**Design and Construction of Civil and Buildings Works including Testing and Commissioning on Design-Build Lump Sum Price basis for Double Line High Speed Railway for Mumbai Underground Station, Cut & Cover Tunnel and Shaft -1 from MAHSR Km. -0.255 to Km. 0.775 at Bandra-Kurla Complex in the State of Maharashtra for the Project for Construction of Mumbai-Ahmedabad High Speed Rail**

**MAHSR - C - 1**

**Response to Bid Queries (Set-2) - 13.03.2020**

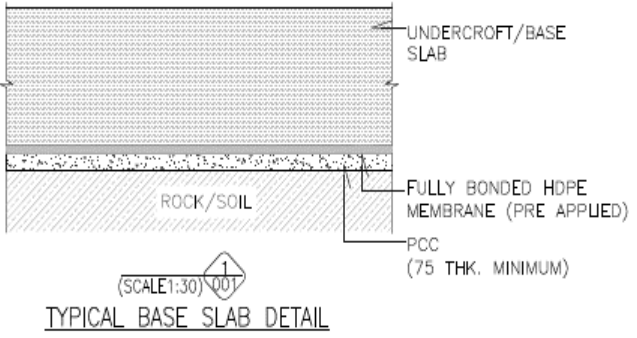
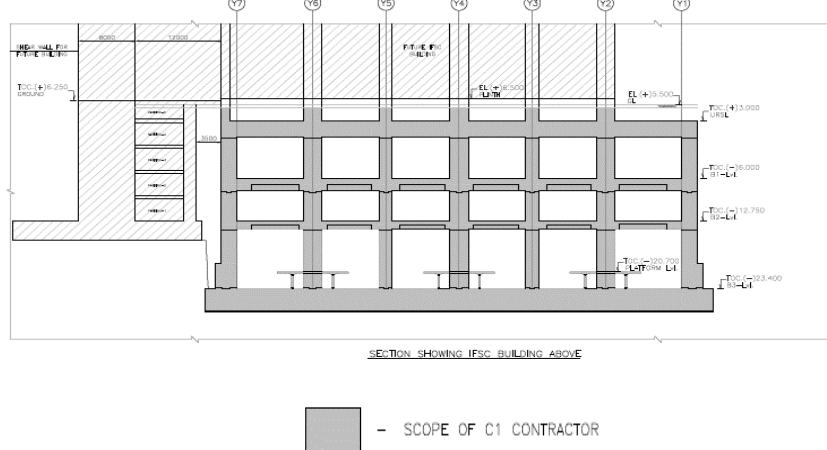
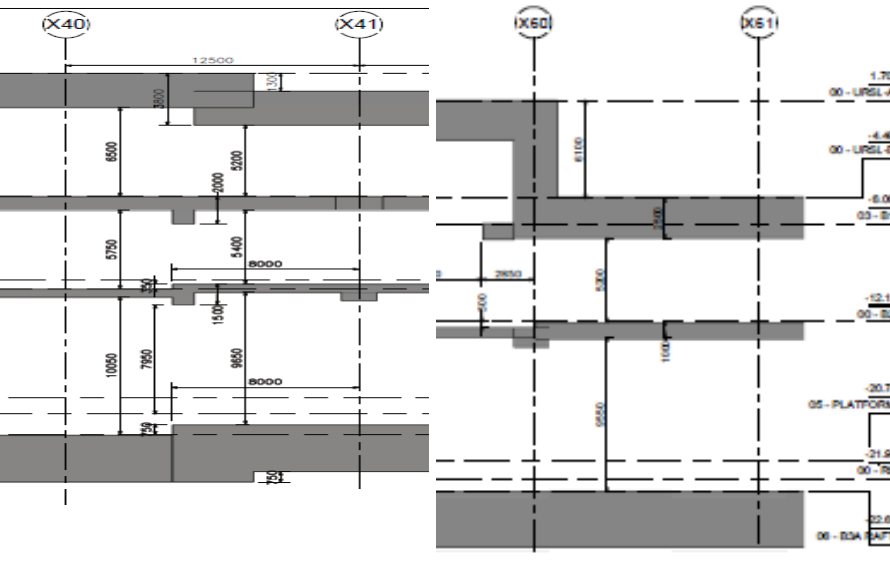
13	Section VI-4, Drawings	#30760001 TBM Temporary wall	Tunnel eye thickness shown in drawing 1500mm	Outer wall thickness of shaft is 1800mm . Please confirm the wall thickness 1500 or 1800mm.	Refer Addendum No. 02, Item No. 37
14	Section VI-4, Drawings	#44040001 and #44010001 Anchor drawings and waterproofing details	The details presented in #44040001 regarding connection of anchor with base slab and corresponding water proofing details for pile anchors are shown in #44010001.	The details presented in #44040001 regarding connection of anchor with base slab is not matching with water proofing details for pile anchors shown in #44010001.	Refer Addendum No. 02, Item No. 37
15	Section VI-3. Employer's Requirements	Clause 11.2 and 11.3 Pg. 30/60	PU Waterproofing and XPS Thermal Insulation and Acrylic Cementitious Waterproofing	The drawings are showing details and specific locations are not presented. Please clarify.	The location of PU waterproofing and XPS insulation shall be designed in detail based on the finishing schedule(BD-JIC-C14-DRW-S01-STA-NTU-01201-000 to BD-JIC-C14-DRW-S01-STA-NTU-01206-000). Acrylic Cementitious Waterproofing shall be applied around doors and windows on exterior walls.  The Contractor shall develop during detailed design for approval of the Engineer.
